Office Action Summary	Application No. 10/677,321	Applicant(s) JANSEN ET AL.
	Examiner SAMEH BOLES	Art Unit 3775

DETAILED ACTION

3. Claims 3-6, 8 are rejected under 35 U.S.C. 103(a) as being unpatentable over Ellis (US. Pat. No. 5171248) in view of Brosseau et al. (US. Pat. No. 6450978 B1).

FIG. 3

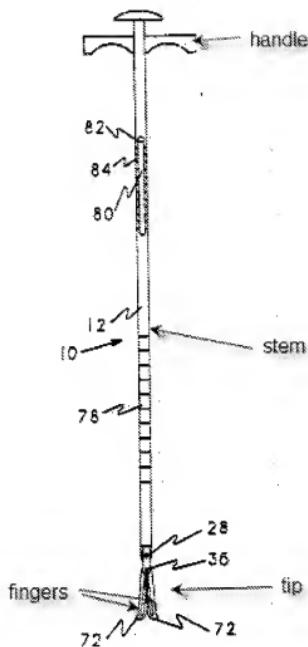
Ellis teaches an apparatus for obtaining an axis of an intramedullary canal of an exposed bone (see modified figure 3 below) comprising: a stem portion (see modified figure 3 below) having a leading end insertable in an intramedullary canal of the bone through an opening in the bone, and being adapted to be handled by a following end thereof; and a tip portion (see modified figure 3 below) at the leading end of the stem portion, the tip portion being positionable in a determined way with respect to a surface of the intramedullary canal, the tip portion has two fingers (see modified figure 3 below) actuatable from the following end of the stem portion to extend radially from the stem portion to center the leading end of the stem portion in the intramedullary canal, wherein

the fingers are pivotally mounted to one another, wherein the fingers are biased to be retracted radially, so as to facilitate an insertion of the stem portion in the intramedullary canal. The stem portion is graduated on an outer surface thereof to indicate a depth of insertion of the stem portion in the intramedullary canal (Fig. 3).
